KGN-HYD - 020-2017.: INTERNATIONAL TENDER FOR REHABILITATION OF EXCITATION, GENERATOR MV SWITCHGEAR, LV SWITCHBOARDS AND PROTECTION SYSTEMS OF GITARU HYDRO POWER STATION -KENYA Clarification 1

Sample block diagram showing all the inputs and outputs of a numerical protection relay/IED as required of the bidder in tender clause 1.4.1.3 (k). See clarification1 item no.7

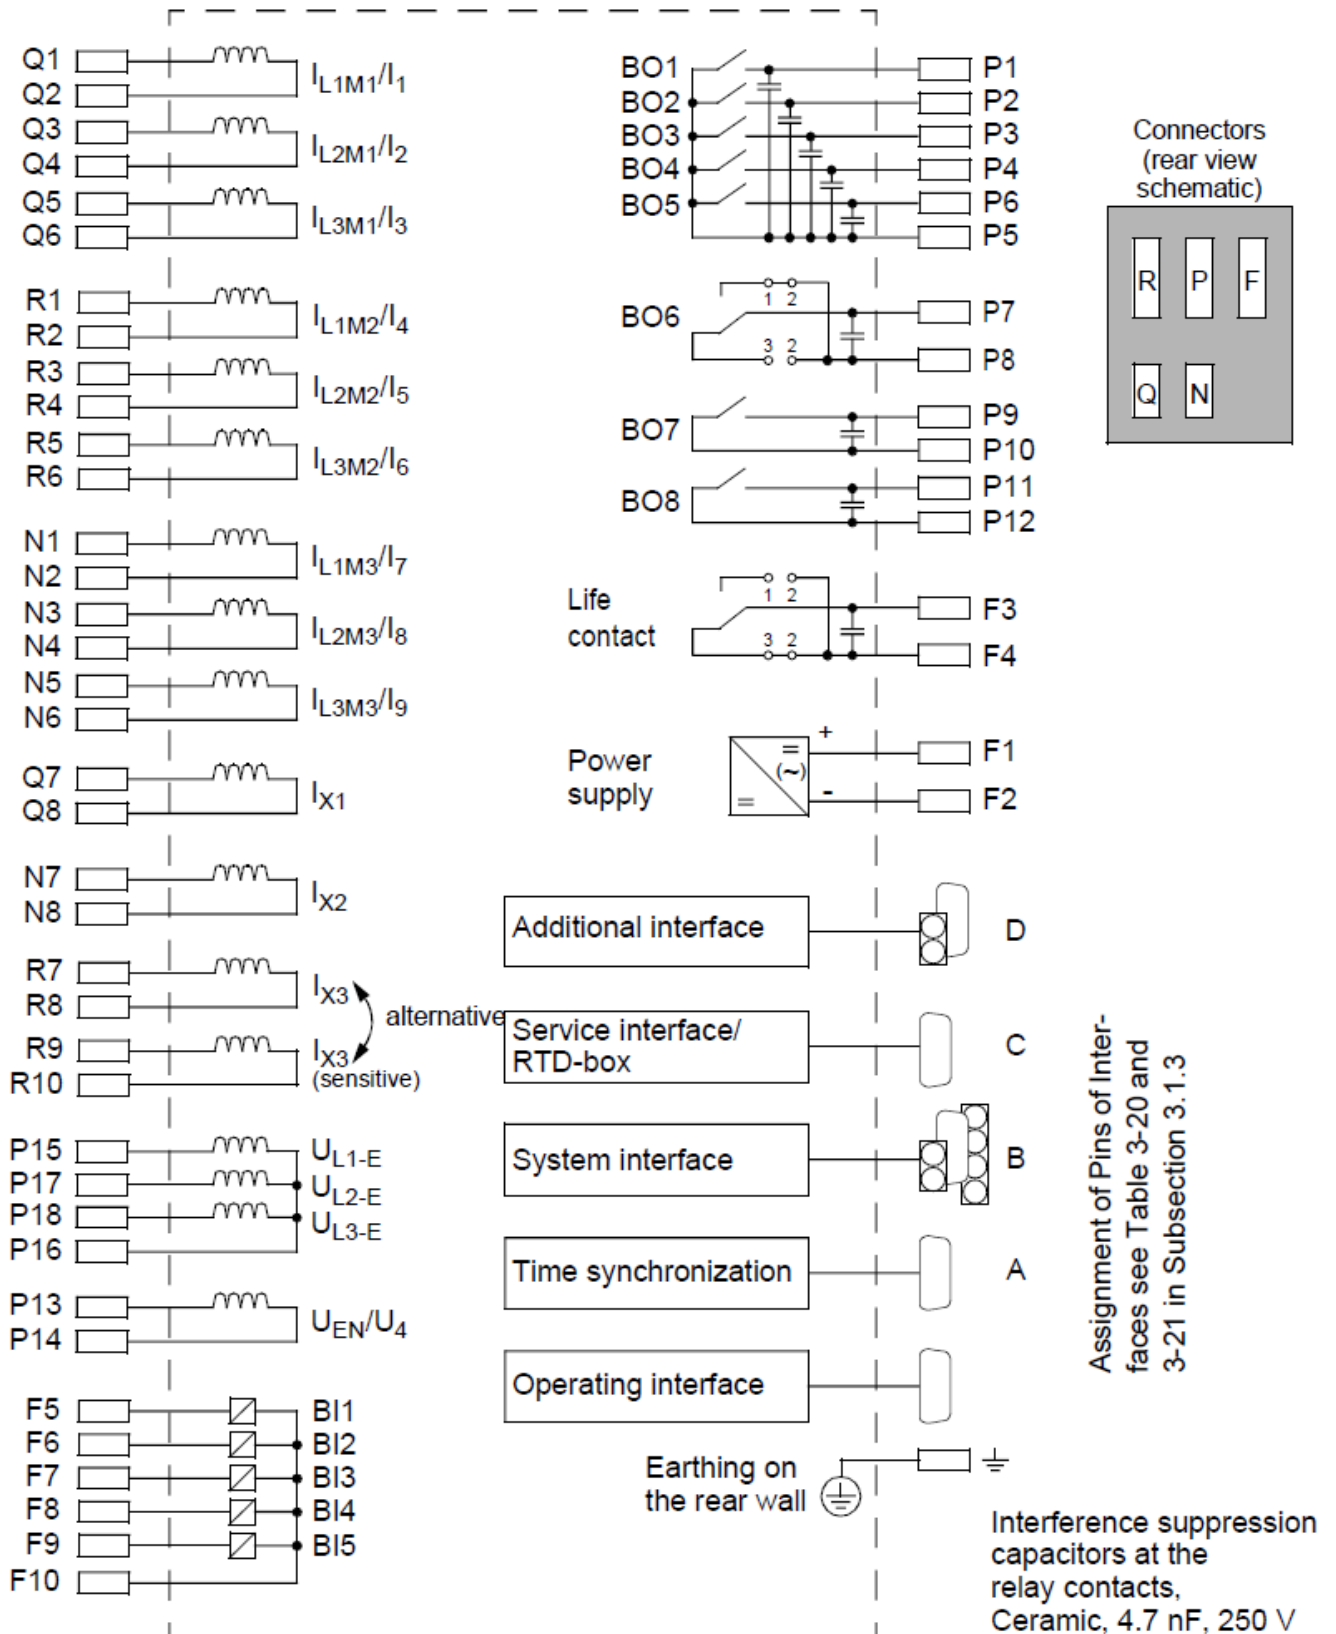
7	1.4.1.3 (k)	Block diagrams showing all inputs and outputs (digital, analogue & serial) for: (i) each type of numerical protection relay, (ii) regulator D-AVR, (iii) converter controller, (iv) Synchronising relay, (v) each type of panel multifunctional meter, (vi) each type of panel indication meters, (vii) Digital power transducer (viii) Each type of Ethernet switch (ix) PTP grand master clock/time server (x) Automatic transfer controller, (xi) Each type of MCCB/ACB ETU, (xii) Remote IO/PLC if offered, (xiii) serial device server and	It is not feasible to provide a block diagram showing all the inputs and outputs during the bidding stage since the design of the system shall not have been done	The employer expects the bidder to submit block diagrams of equipment the bidder proposes to use. The block diagram shall show all the inputs and outputs as given by the manufacturer and not how they shall be configured for the project. Below see a sample block diagram of a numerical relay showing all inputs and outputs

Item No.	TENDER CLAUSE NO.	TENDER ARTICLE	Question/additional information sought by tenderers.	Clarification
		(xiv) any other IED's offered. This shall be separate from the manuals i.e. a separate block diagram for each type of device above offered, DO NOT QUOTE the manuals		
8	1.7.3.6	All client's drawings of power plant systems (not forming part of scope of this project) interfaced to the new excitation, protection, metering, SCADA interface and switchgear systems shall be reviewed and updated by the contractor. The client shall provide pen-marked drawings to the contractor who shall provide revised drawings in similar fashion to the drawings of systems supplied by the contractor	Please confirm that Supplier scope can be limited to pen mark up ("red marked") of the existing documentation of plant equipment interfacing with new supply Are the client drawings to be reviewed available in AutoCAD	All drawings shall be reviewed and updated as elaborated in the aforementioned clause of the tender. Contractor shall provide soft and hardcopy of all these drawings as detailed in clause 1.7 of specifications Employer's drawings are only available in hardcopy
